**THE METROPOLITAN DISTRICT  
HARTFORD, CONNECTICUT**

**SPECIAL DEVELOPMENT DISTRICT AND ZONE  
CHANGE REQUEST FOR SOUTH TUNNEL ACCESS  
SHAFT AT 1 CHARTER OAK BOULEVARD IN  
TOWN OF WEST HARTFORD**

Re: Special Development District and Zone Change Request Application #144  
Metropolitan District Commission (MDC) in conjunction with the South Hartford  
Conveyance and Storage Tunnel Project.  
**Supplemental Project Information and Request**

DOCUMENT REVIEW COMMENTS			
Job No.: <b>60287608</b>	Title: <b>West Hartford Zone Change/SDD Request</b>	Date: <b>7/16/15</b>	
Preparer: <b>James Sullivan</b>	Reviewer: <b>Town of West Hartford</b>	Responder: <b>Various/Below</b>	
Discipline: <b>MDC South Tunnel - All</b>	Status:	<input type="checkbox"/> Criteria <input type="checkbox"/> 100% <input type="checkbox"/> 90%	<input type="checkbox"/> 60% <input type="checkbox"/> 30% <input checked="" type="checkbox"/> <b>SDD and Zone Change Application</b>
REVIEW PURPOSE:	<input type="checkbox"/> Independent Peer Review <input type="checkbox"/> Discipline <input type="checkbox"/> Project Approach Review	<input type="checkbox"/> Interdiscipline <input checked="" type="checkbox"/> Other	Action Code:

**230 C-100**

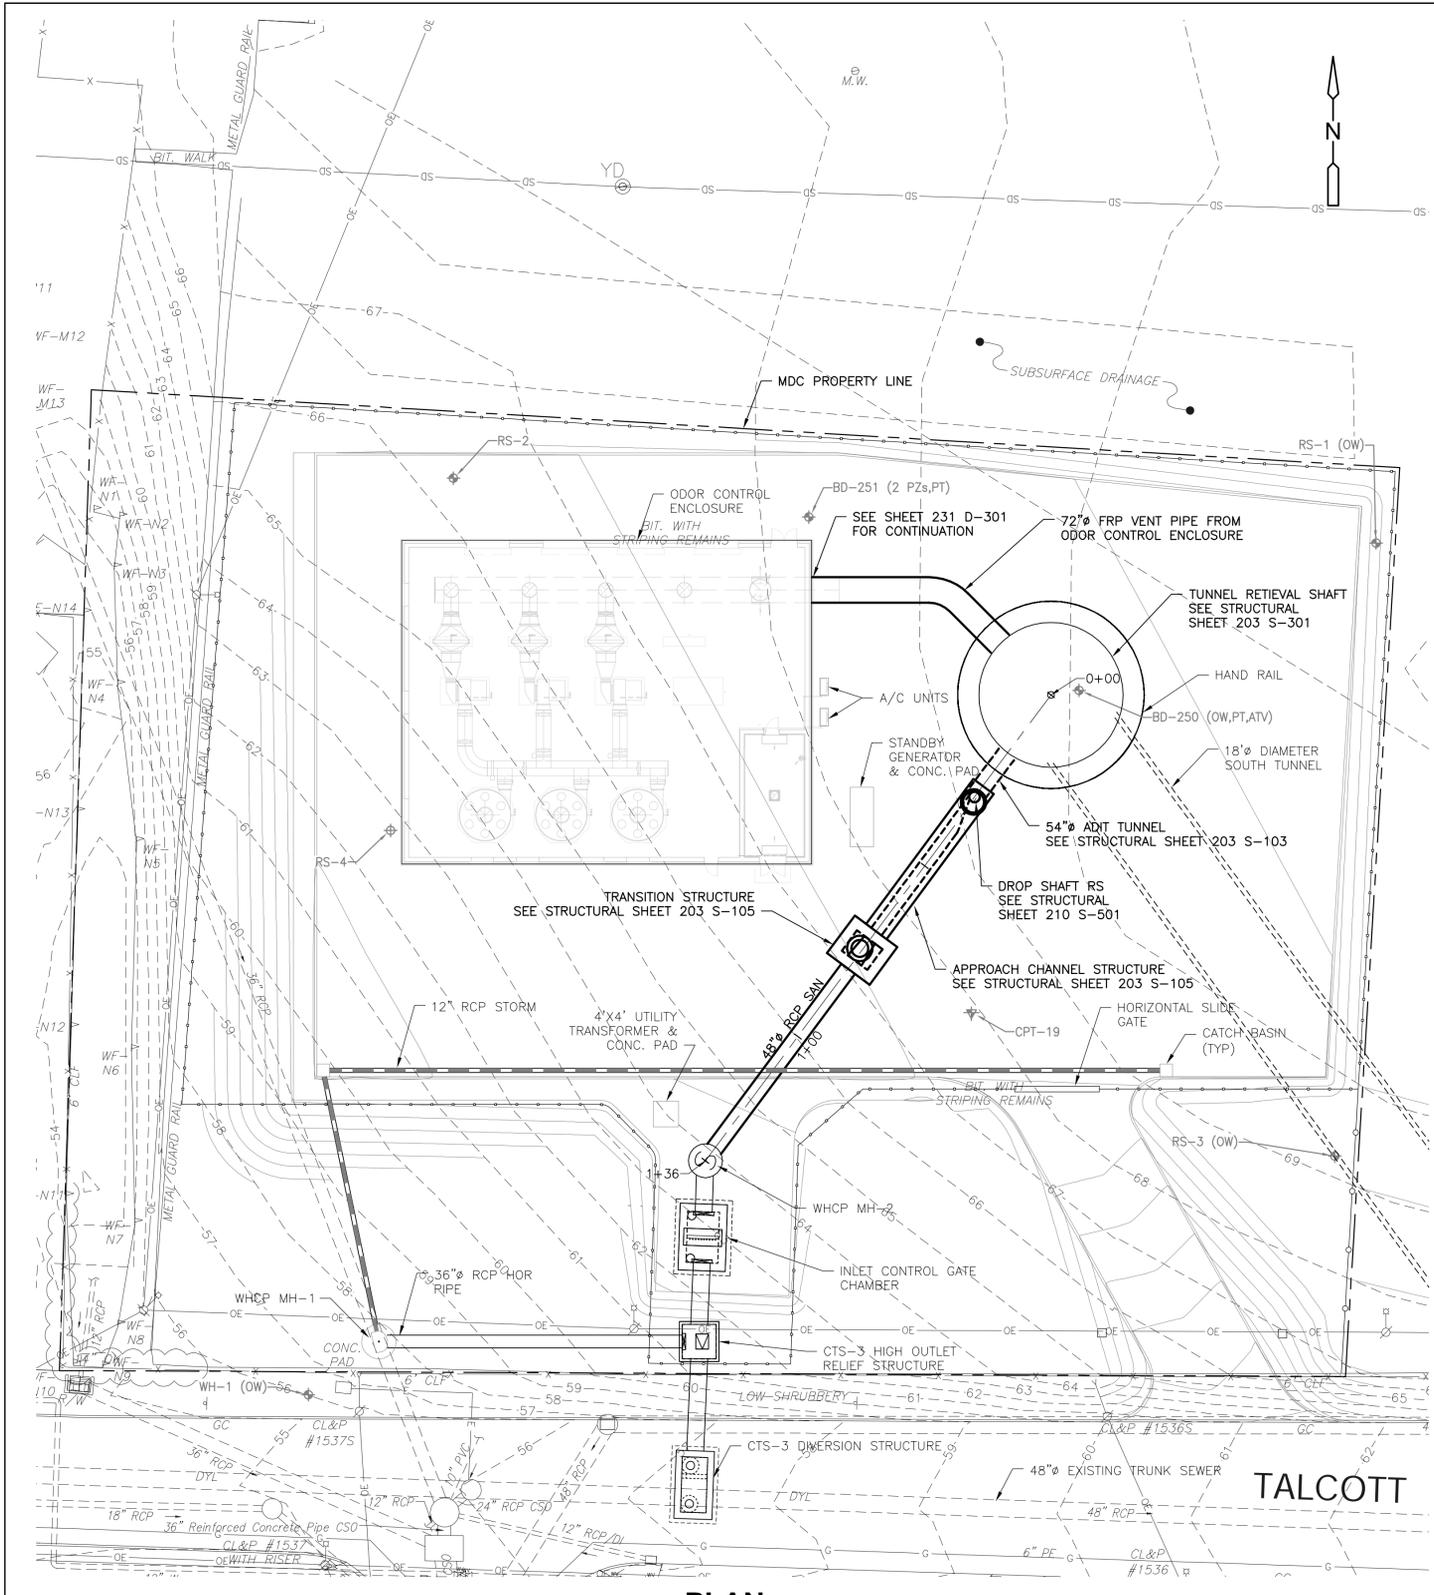
No.	COMMENT	ACTION/RESPONSE
P-1	The plan set Cover Sheet should be updated as follows: a. The locus map should identify the location of the project site. b. The scale of the locus maps should be increased to a larger scale. Staff suggests 1"=500' and inclusion of areas only in West Hartford. c. The title shall be updated to include reference to "Special Development District and Zone Change Request". Included in the title should be reference to the location of the project site.	A revised index sheet, addressing Comments 1a., 1b., and 1c., has been prepared and is included in the modified plan set (Enclosure F).
P-2	A proposed zoning map should be included in the plan set a. Staff suggests using the existing zoning depicted on Figure 1, page two of the application, and creating a new zoning map in the plan set based off the Acquisition and Easement Map contained in the application. b. The zoning map should include, existing zones, proposed zone change area and depict the proposed SOD overlay boundary around the entire property, building setbacks and the building lines.	A proposed zoning map has been developed and is included in the modified plan set (Enclosure F).

PLAN NUMBER  
SHEET NO.  
**230 C-101**

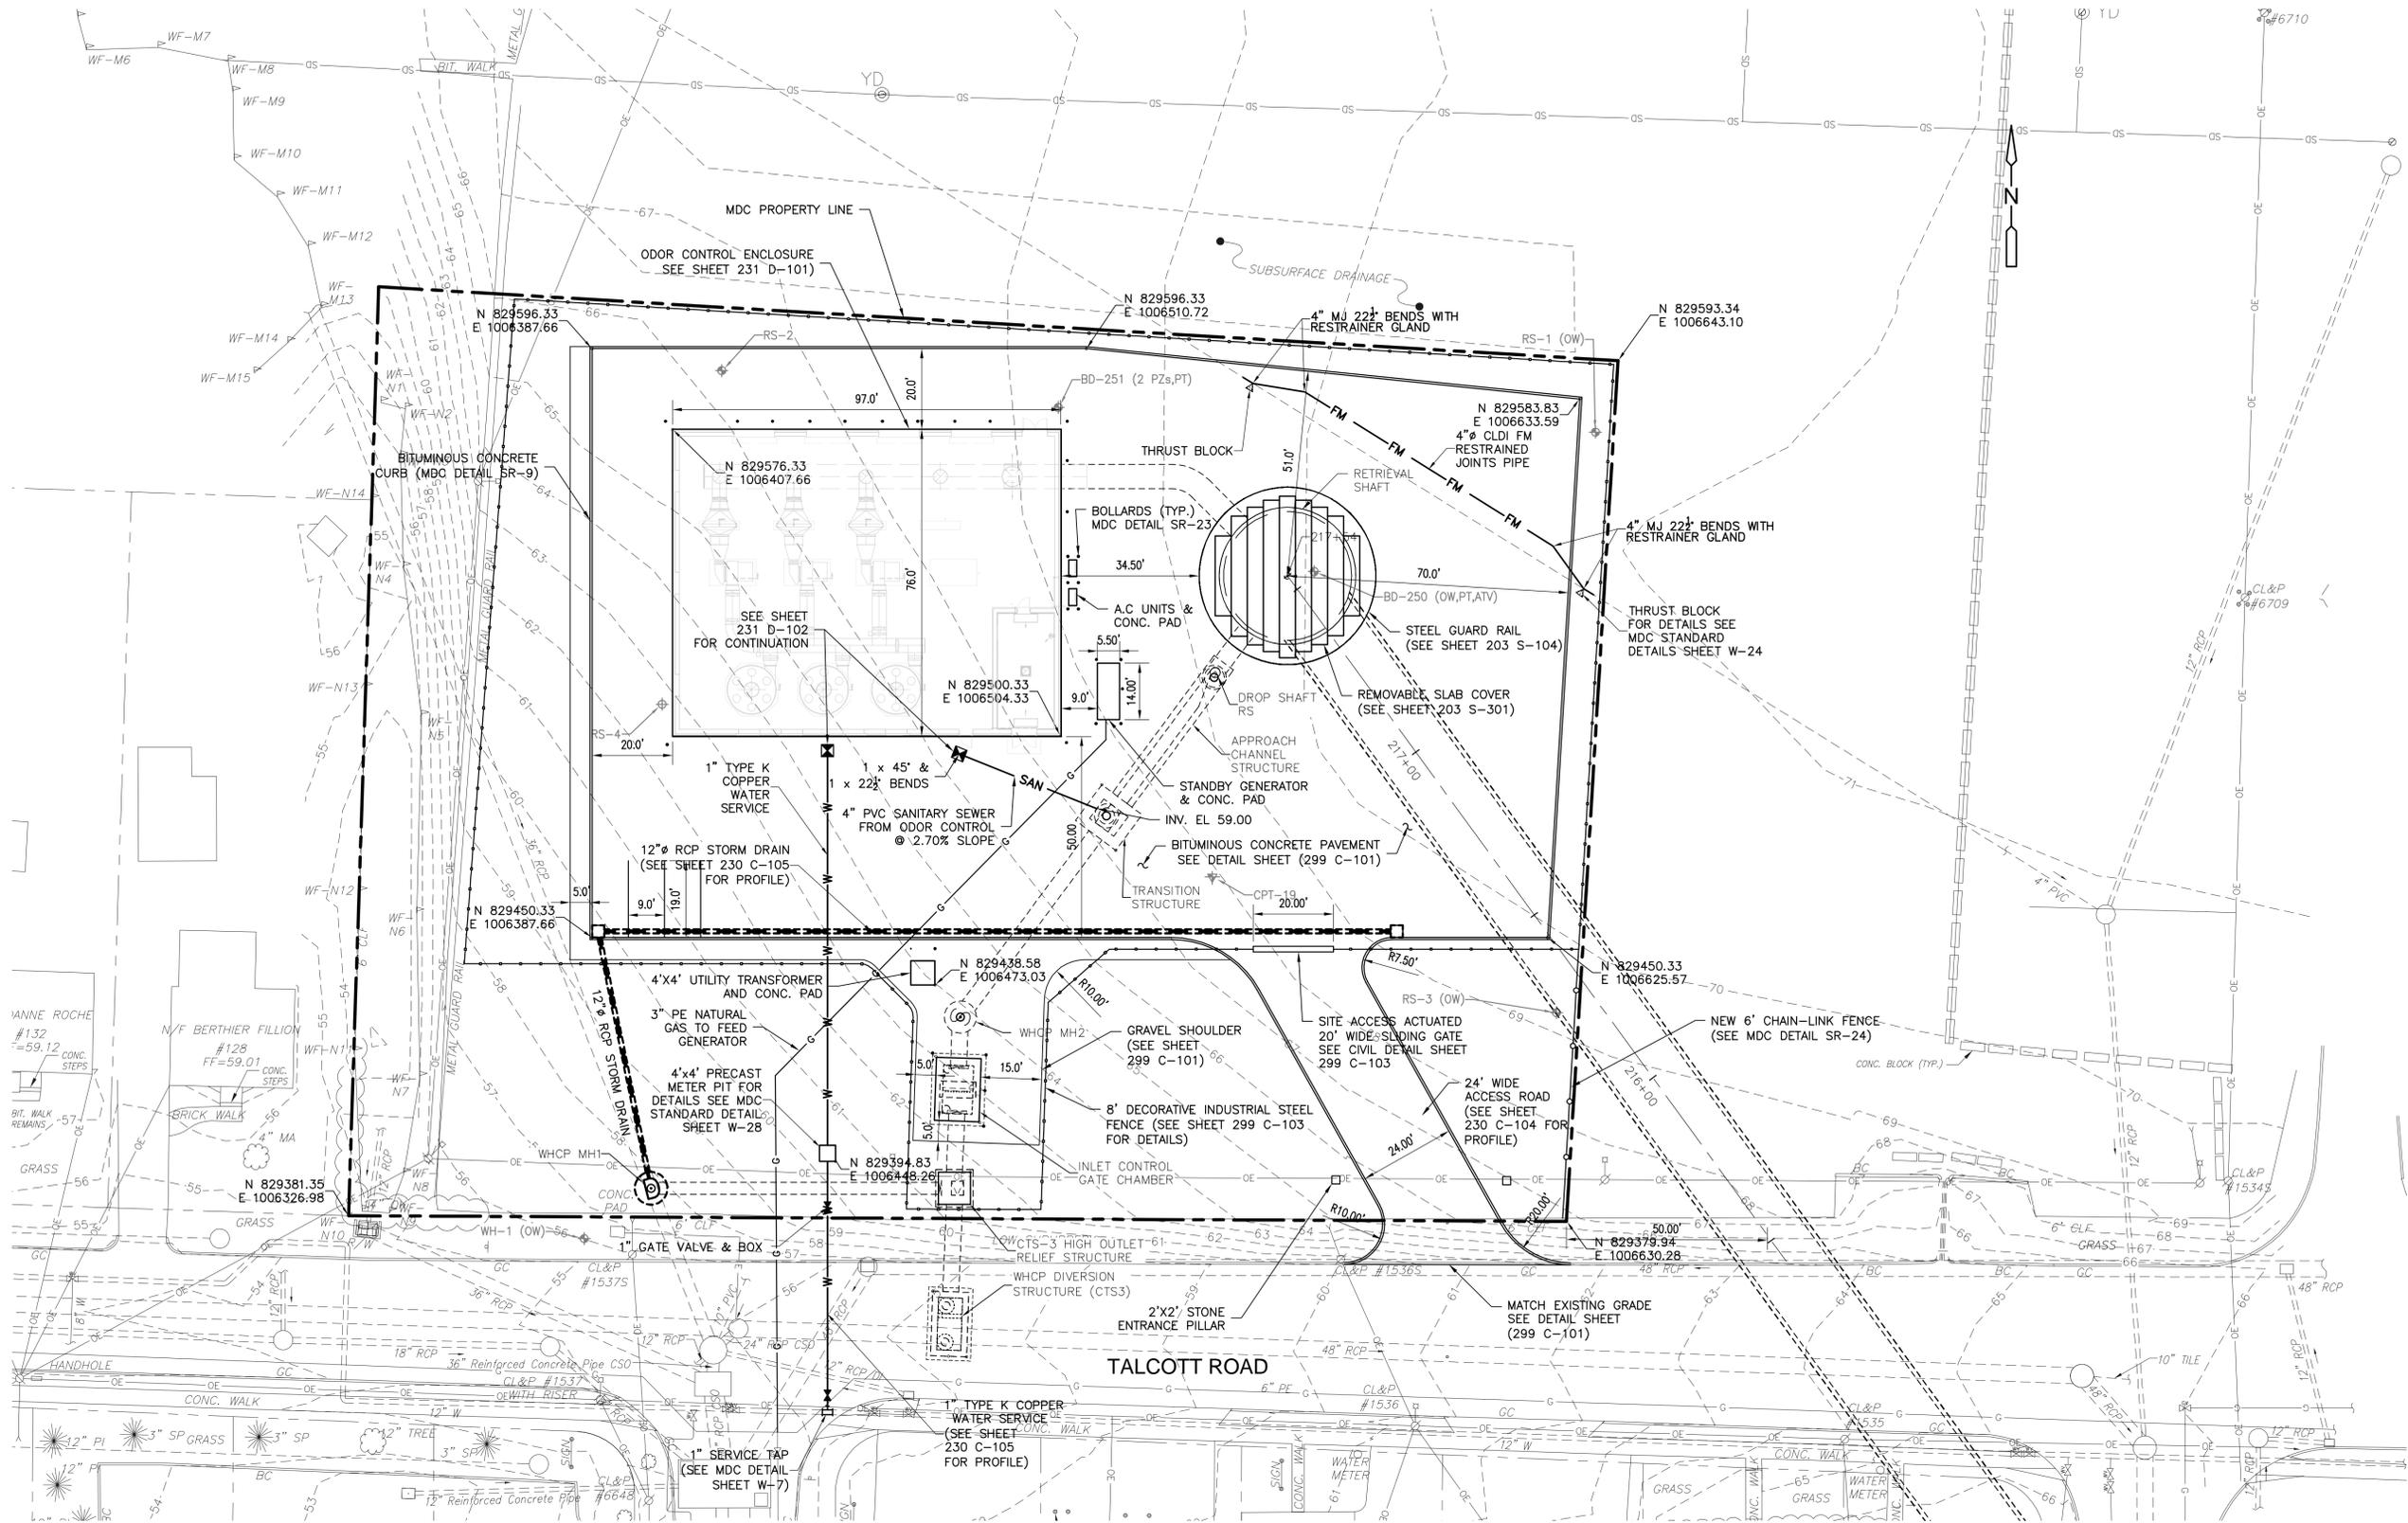
P-6	<p>The plan shall demonstrate compliance with Section 177-27 and 177-32 Drainage water and Parking. More specifically, the review comments provided by the Town Engineering Division in their 7/2/15 memorandum shall be addressed.</p>	<p>A meeting was held on 7/16/15 to discuss Engineering comments. Responses to Engineering comments provided below.</p>
P-7	<p>The plan shall demonstrate compliance with Section 177-32 Parking. More specifically the following items should be addressed or clarified:</p> <ul style="list-style-type: none"> <li>a. Parking areas and required loading areas should be identified on the plan set.</li> <li>b. The driveway width is insufficient for two-way vehicle operation and shall be increased.</li> </ul>	<p>The parking areas and loading areas are shown on Sheet 230-C-106. The driveway width has been increased to 24 feet as shown in the modified plan set (Enclosure F).</p>

REV. NO.	DATE	DRWN	CHKD	REMARKS
1	7/16/15	SG	JS	REVISED DRIVEWAY WIDTH AND FENCE LINE PER TOWN REVIEW COMMENT

PLAN NUMBER  
 SHEET NO.  
**230 C-105**

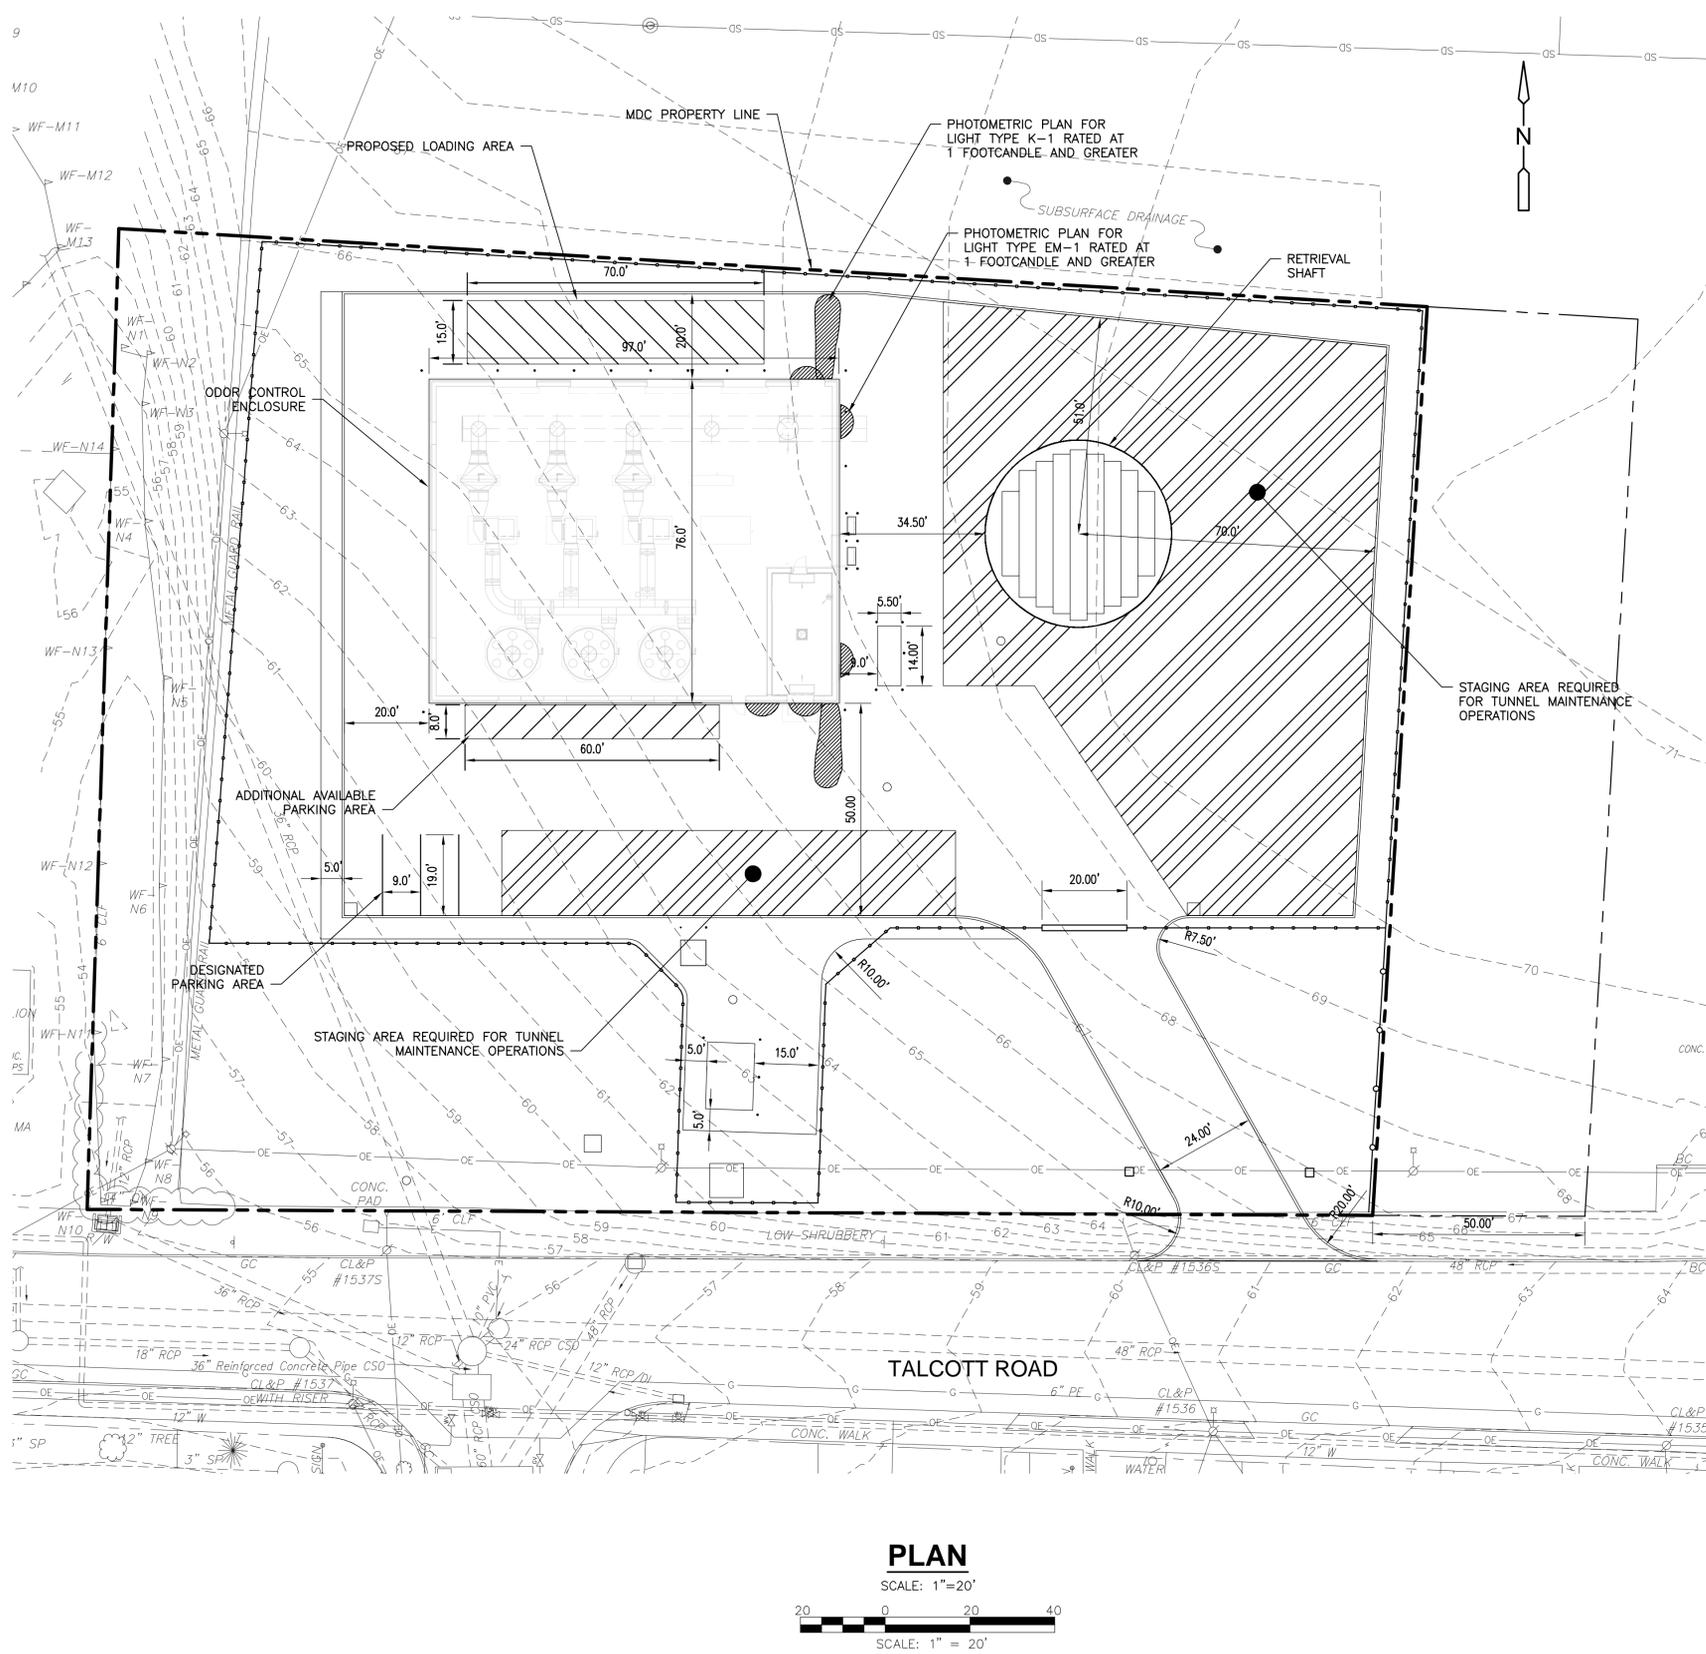
P-3	The plan shall demonstrate compliance with Section 177-6 C Standards for Industrial Districts. More specifically the following items should be addressed or clarified: a. A Zoning Compliance Chart shall be provided for existing and proposed conditions. Floor Area Ratio (F.A.R.), building coverage, building height, yard and screening requirements, and parking were not tabulated nor reported in the plan set. This chart should be included on either sheet 230 C-144 or by creating a new overall project site plan sheet. The overall site plan sheet should depict the existing setback requirements. b. If compliance with a specific standard cannot be demonstrated, a Special Development District (SDD) modification request may be required.	A Zoning Compliance Chart has been prepared and is presented on Sheet 230 C-106 (refer to Enclosure F).

Lighting	All on-site lighting has been specified to be shielded. Refer to the site Photometric Plan (Sheet 230-C-106).	Article IV: General Regulations §177-25 <i>Any outdoor lighting shall be so shielded that the light source cannot be seen from adjacent properties.</i>
Drainage	The majority of surface water runoff will flow to a perimeter gutter, and catch basin located in the southwest corner of the site (Sheet 230 C-103). The gutter channel, catch basin, and 12-inch drain line have been sized to accept and transport the peak runoff from the 10-year storm event without ponding or surcharging. The overall site plan reduces the impervious surface by 23,524 SF (39%), resulting in improved stormwater runoff quality.	Article IV: General Regulations §177-27 <i>No structure shall be erected, and no land shall be graded or hard-surfaced, unless provisions have been made and approved by the Department of Community Services for the proper disposal of drainage water.</i>
